UNITED STATES PATENT AND TRADEMARK OFFICE

APPLICATION NO.	FILING DATE	FIRST NAMED INVENTOR	ATTORNEY DOCKET NO.	CONFIRMATION NO.
10/666,542	09/19/2003	Thomas R. Apel	TRQ-12923	5554
Joseph Pugh 7590 TriQuint Semiconductor, Inc. 2300 NE Brookwood Parkway Hillsboro, OR 97124			EXAMINER SHINGLETON, MICHAEL B	
			ART UNIT 2815	PAPER NUMBER
			MAIL DATE 06/26/2008	DELIVERY MODE PAPER

Office Action Summary

DETAILED ACTION

Figure 2 (Taniguchi)

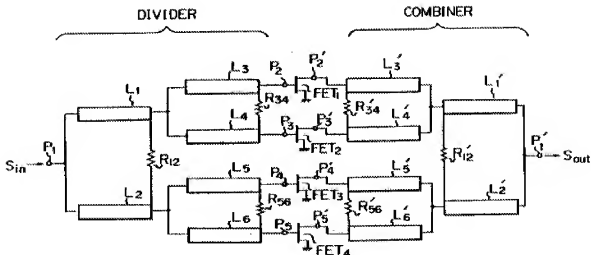
Figure 2 of Taniguchi discloses a power amplifier circuit. Note that the goal of these circuits of Taniguchi is to “obtain a high power high frequency signal” (See column 3, around line 59) and thus these circuits are power amplifier circuits. Taniguchi includes a first amplifier “subsection” L_3 and FET_1 (Herein and throughout referred to just as the first amplifier.) that is configured to receive an input signal that is the unmarked signal at the node that directly connects elements L_1 , L_3 , and L_4 . Note that the first amplifier receives this signal through element L_3 . This is only giving the broadest reasonable interpretation to the claims consistent with the specification. See MPEP 904.01. The first amplifier clearly provides a “first” output signal. Element L_4 of Taniguchi is a first delay element that introduces a delay to the input signal and applies this to the input of a “second” amplifier “subsection” FET_2 (Herein and throughout referred to just as the second amplifier.). This second amplifier clearly has an output signal and provides a “first” delayed output signal to the node directly connecting elements L_3' , L_4' and L_1' . The top of page 9, of applicant’s specification clearly sets forth that an impedance inverter can be a quarter wavelength transmission line. Thus all the quarter wavelength lines of Taniguchi are “impedance inverters” as set forth by applicant and is in accordance with applicant’s application. These impedance inverters of Taniguchi are in accordance with applicant’s specification provides the “impedance inversion”. Thus the impedance/delay element L_3' also introduces a second delay to the first output signal thereby creating a second delayed output signal. The node directly connecting elements L_3' , L_4' and L_1' and the node directly connecting elements L_5' , L_6' and L_2' in combination with the node that directly connects elements L_1' and L_2' provides the means for combining the first and second delayed output signals that ultimately provides the high frequency amplified output signal S_{out} . This output signal is provided on the output terminal “ P_1 ”. Taniguchi is silent on showing the bias circuit and supply circuit or what applicant calls “level control circuit” in claims like claim 1 for example that biases the first and second amplifiers to operate in the saturation range, i.e. non-linear classes of operation. Applicant should note that while Taniguchi is silent on the bias circuit or “level control circuit”. As is known to those of ordinary skill in the art, Taniguchi inherently must have a bias circuit and power supply circuit because this is a necessary circuit needed so that the amplifier(s) can operate.

The structure indicated above clearly provides for the claimed method of the claims indicated at the beginning of this rejection except for as indicated above Taniguchi is silent on providing a bias control circuit/level control circuit that biases the amplifiers such that non-linear operation is obtained.

Figure 2(Apel)

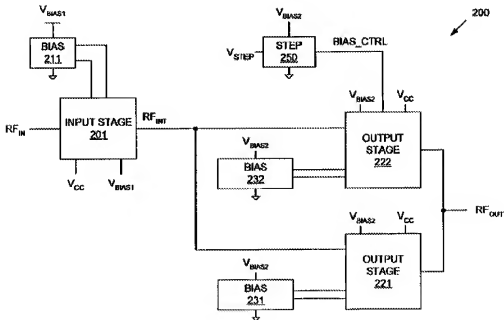
Figure 2 of Apel teaches one way to have a multi-channel amplifier arrangement provide for low power and high power modes. This includes the providing of a “bias control circuit” 231, 232, 250 that enables the first amplifier 221 when the “level control signal” V_{STEP} is set for a low power mode and which enables the second amplifier 222 when the “level control signal” is set for a high power mode.

Thus it would have been obvious to one of ordinary skill in the art at the time the invention was made to provide the combination of Taniguchi and Holt with a bias control circuitry such as that of Apel so as to enable the first amplifier during a low power mode indicated by a level control signal and enable both the first and second amplifiers when the level control signal indicates a high power mode. Therefore the multi-channel amplifier arrangement can be made to provide more than one power level output mode as taught by Apel.

Note that the selection of the bias points of the bias circuits in the combination of Taniguchi, Holt and Apel results in the level control circuit, i.e. the unshown circuit that provides the level control signal V_{STEP} , to allow for the level control circuit to cause the first and second amplifiers to operate in the saturation mode when these amplifiers are enabled.
